## Waste Management Facility, Botany

Integrated Water Management Strategy

A response to this submission was provided by Bayside Council (their ref: SSD-2024/10) dated 09/09/2024 – and the response to their civil engineering queries is summarised below (note flood and landscape related queries are responded to in other respective reports):

A response to this submission was provided by Department of Planning, Housing and Infrastructure (their ref: SSD-62855708) dated 13/09/2024 – and the response to their civil engineering queries is summarised below (note landscape related queries are responded to in other respective reports):

Figure 5. MUSIC Model Treatment Train and Results

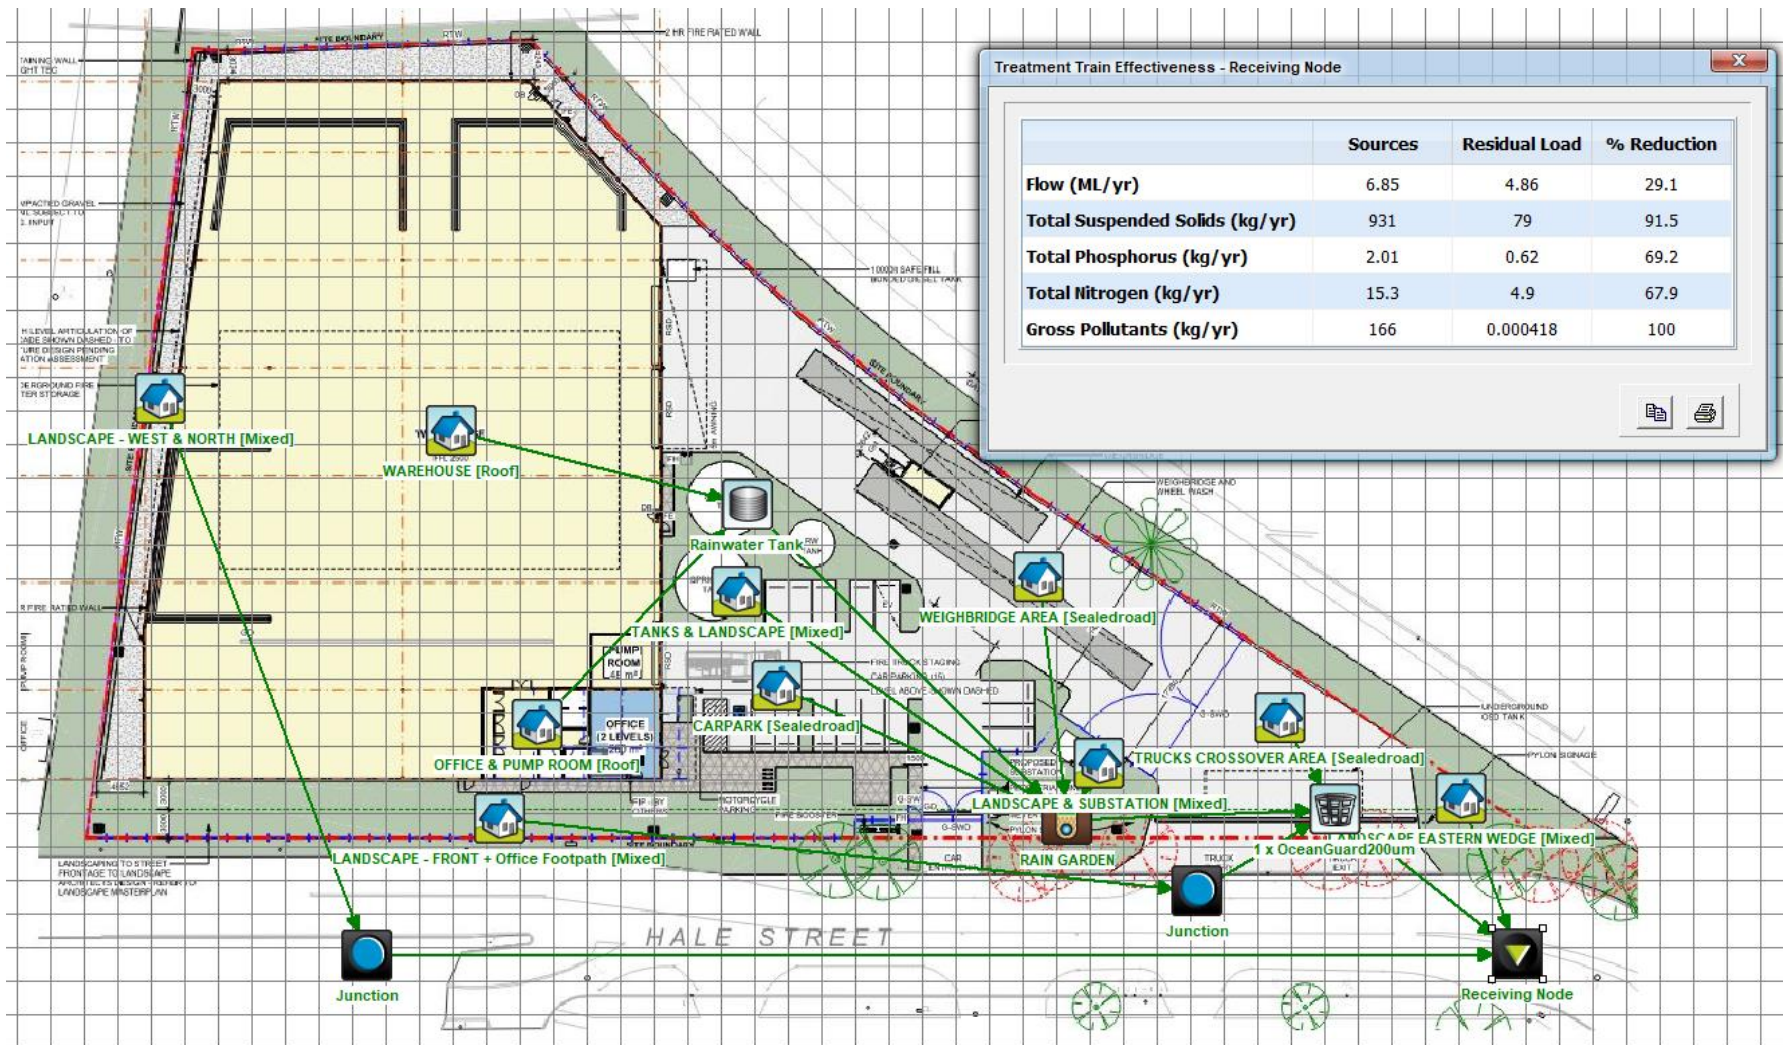
<p>Furthermore, figure 5 of this report cannot be assessed as it does not include the areas of each catchment and is not supplemented by stormwater plans verifying the catchment areas and demonstrating the treatment train is feasible.</p>	<p>Refer to Table 4 on Section 5.8 and Catchment area plan in Appendix C</p>	<p>Section 5.8: Table 3; Appendix C</p>
<p>The parameters of the bioretention system in the MUSIC model shall be shown. The bioretention system appears to be overperforming and it’s not clear how the site will effectively capture gross pollutants from impervious areas. Furthermore, it needs to be detailed how this system will work given the substation and trees proposed in this area.</p>	<p>This is included in the soft copy of the MUSIC file provided for council review.</p>	<p>Attached .sqz file</p>
<p>A soft copy of the amended MUSIC modelling shall be provided.</p>	<p>As above</p>	<p>Attached .sqz file</p>

### **9. APPENDIX B. PROPOSED STORMWATER DRAINAGE SCHEME**

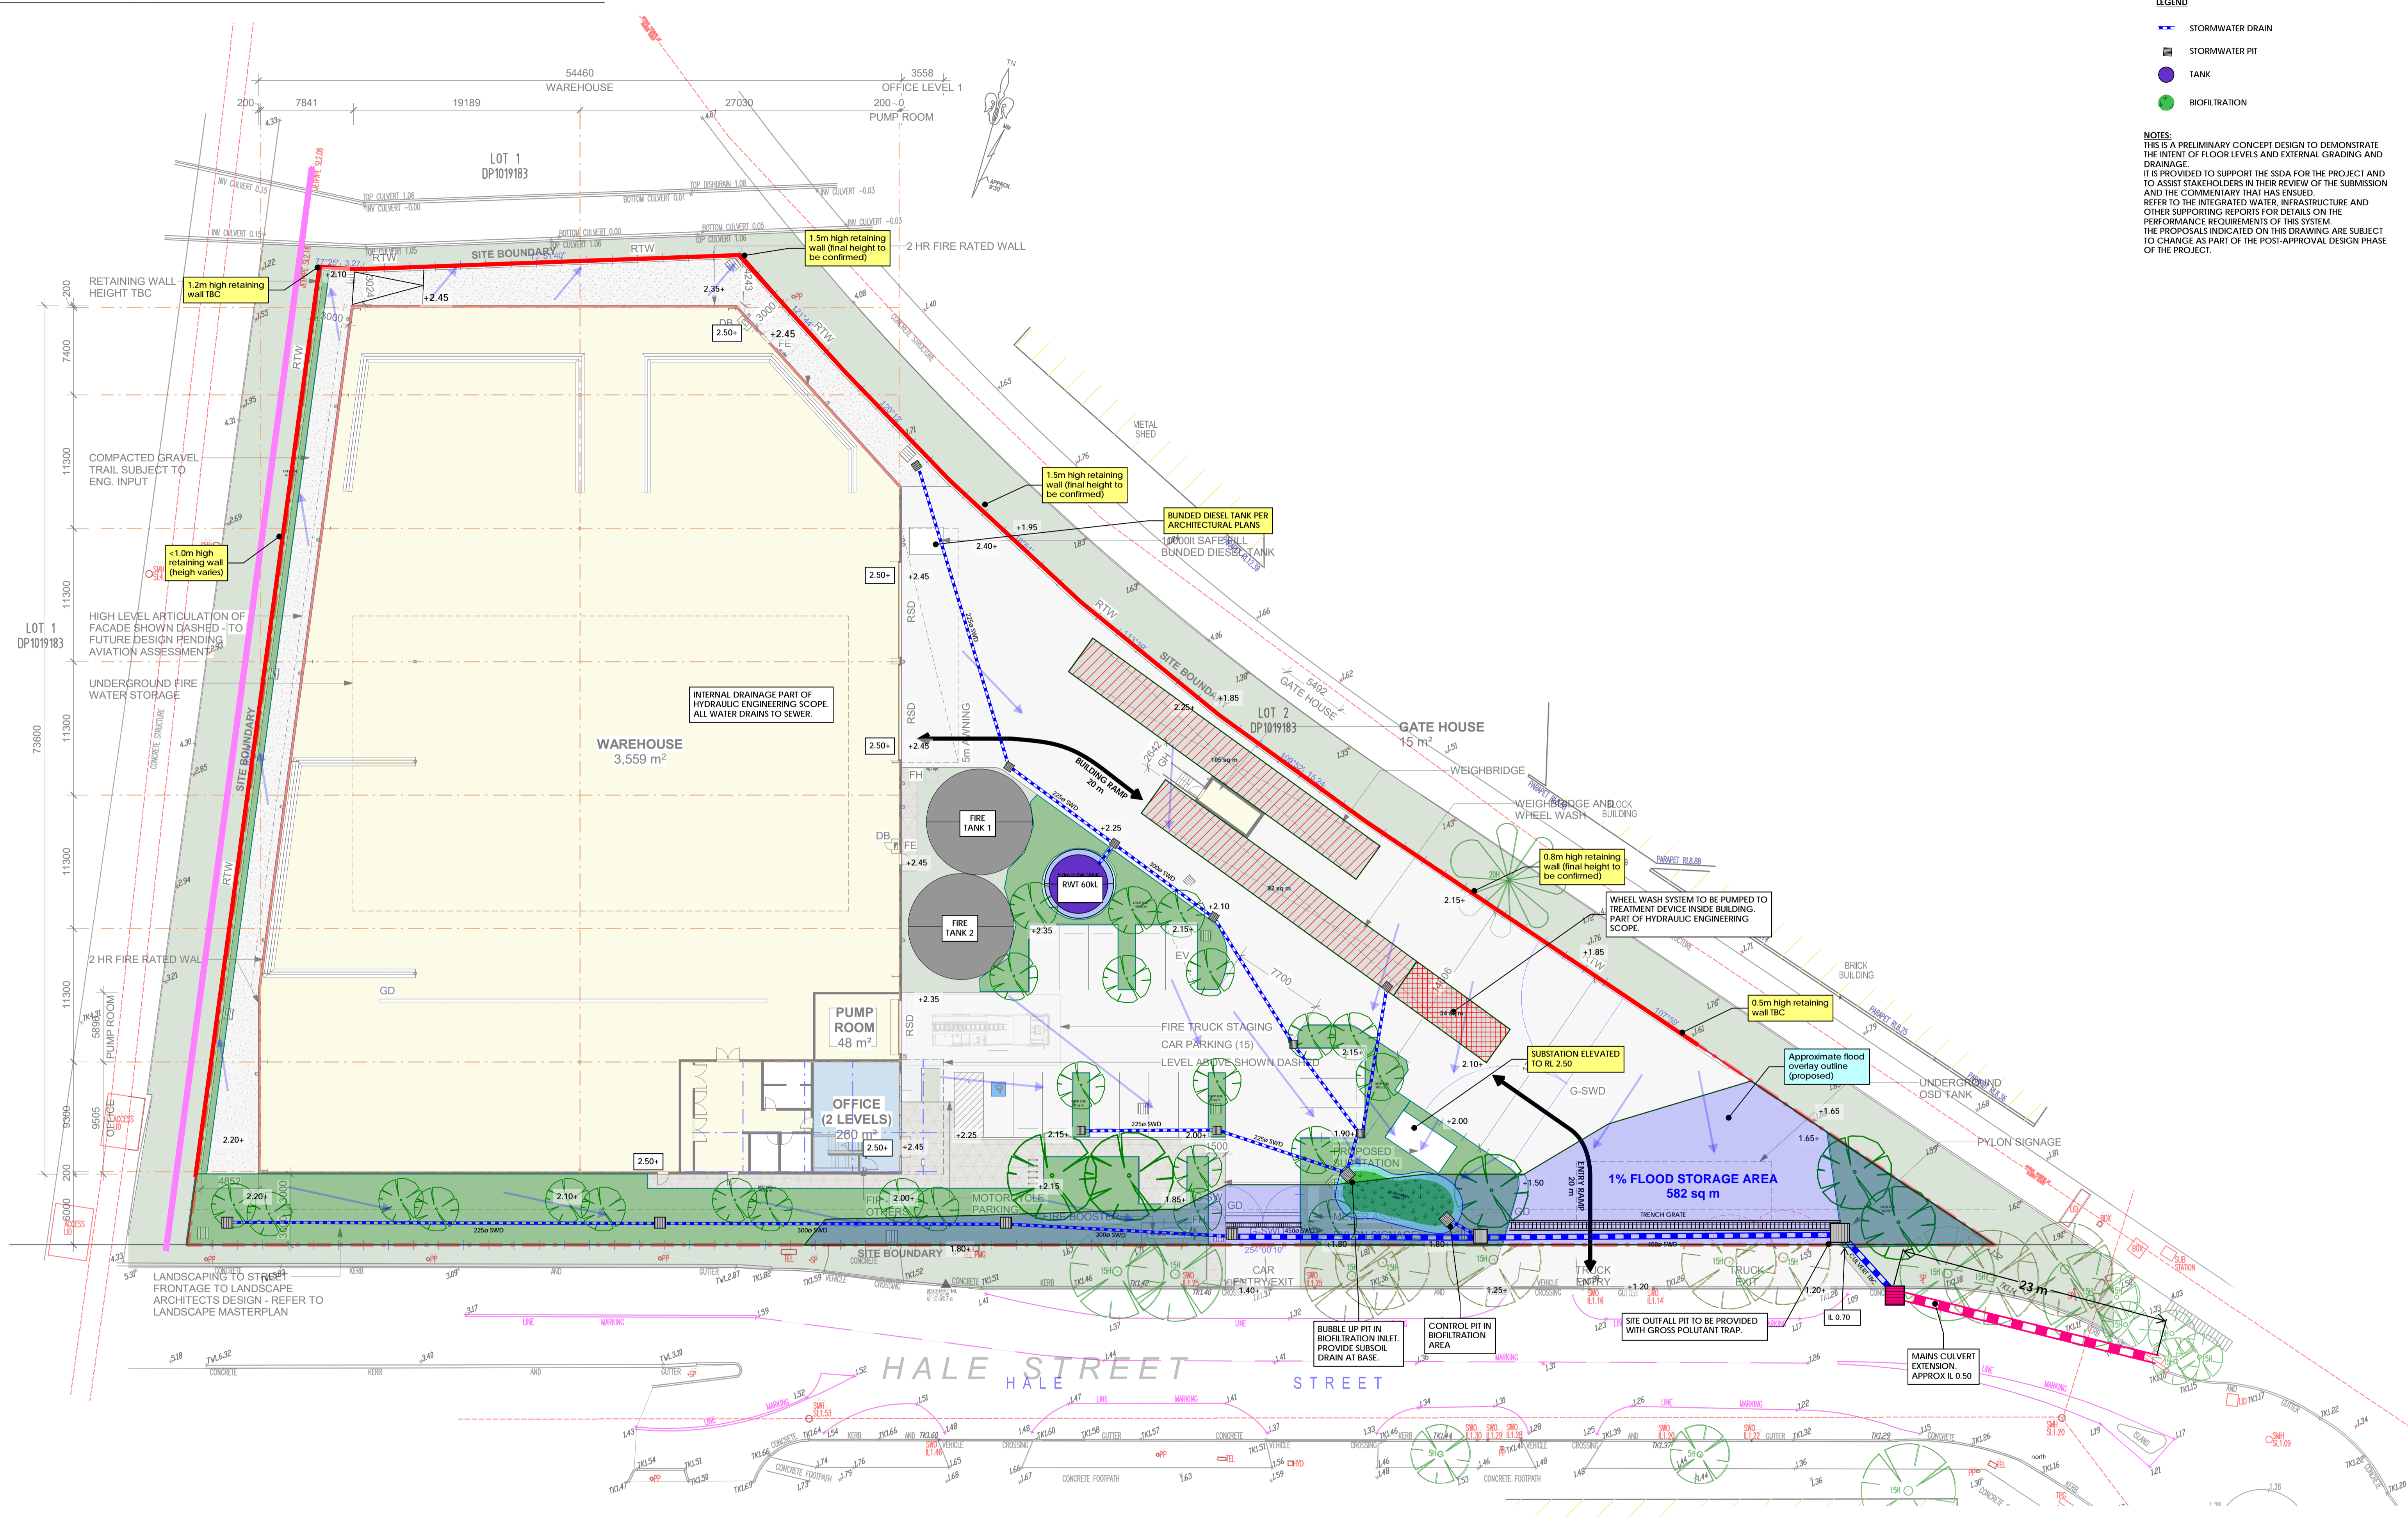
Bayside Council Comments	Proponent Response	Location Addressed
<p>It's not clear how the building is set at or above the flood planning level (1% AEP flood level + 500mm freeboard) given Council's flood model indicates flood levels of RL 2.92m directly to the west of the proposed building.</p>	<p>As discussed in the council pre-application meeting the spurious data along the western boundary is due to the lidar data in the council model which is slightly different than the actual topography in this location, largely resulting from issues with lidar representation in the model.</p> <p>This information is reflected in the attached civil concept plan.</p>	<p>Appendix D and B show the updated survey data and proposed level concept respectively.</p>

<p>The substation is to be flood proofed to the 1% AEP + 500mm level.</p>	<p>Noted. The electrical substation floor level is set at 2.5m which is above 1% AEP + 500mm freeboard.</p>	<p>Appendix B shows the proposed level of the substation.</p>
<p>A set of stormwater plans prepared by a suitably qualified civil engineer were not provided. As a result, the development cannot be assessed to determine if it satisfies clause 6.3 and clause 5.21 of the Bayside LEP and the requirements of the Bayside DCP (section 3.9, 3.10 and 9.5). These plans need to be provided to enable the development to be fully assessed.</p>	<p>We have included a revised and more detailed concept in Appendix B for reference. The provision of a full set of detailed design plans is not typical at this stage of a development application as it will be undertaken at Construction Certificate stage, however the information now included in Appendix B should provide enough detail to facilitate review</p>	<p>Appendix B</p>

Bayside Council Comments	Proponent Response	Location Addressed
<p>The stormwater plans shall include the following details at minimum:</p> <ul style="list-style-type: none"> <li>• Site layout;</li> <li>• Surface and roof drainage plans;</li> <li>• Existing site contours and final design levels;</li> <li>• WSUD catchment plan;</li> <li>• Finished floor levels and footprints of the proposed development/ structures;</li> <li>• Location and size of the internal and external drainage systems, rainwater re-use system, flood storage tank systems;</li> <li>• Levels and location of discharge points for the stormwater system including design details of the Hale Street drainage extension;</li> <li>• Cross-sections details of the rainwater tanks and flood storage tank;</li> <li>• Maximum water surface levels in each storage;</li> <li>• Details of surcharge/overflow paths for the major storm;</li> <li>• Location and manufacturer spaces of stormwater quality improvement devices; and</li> <li>• Flood storage tank base plan is to be provided, showing all base levels and minimum 1% fall towards the outlet pipe;</li> <li>• A lid plan is to be submitted for the flood storage tank; showing the distance from pit centre to centre. The grates spacing of the access grates to be as per Section 6.6.2 of Bayside Technical Specification Stormwater Management.</li> <li>• Full details of the bioretention system including manufacturers details.</li> <li>• Construction and operational phase sediment and erosion control plan.</li> </ul>	<p>As noted above we have provided a more detailed concept plan that indicates the majority of this information – that we believe is appropriate at this stage of the development process.</p> <p>The degree of detail requested here is achievable in the detail design phase of the project.</p>	<p>Appendix B</p>
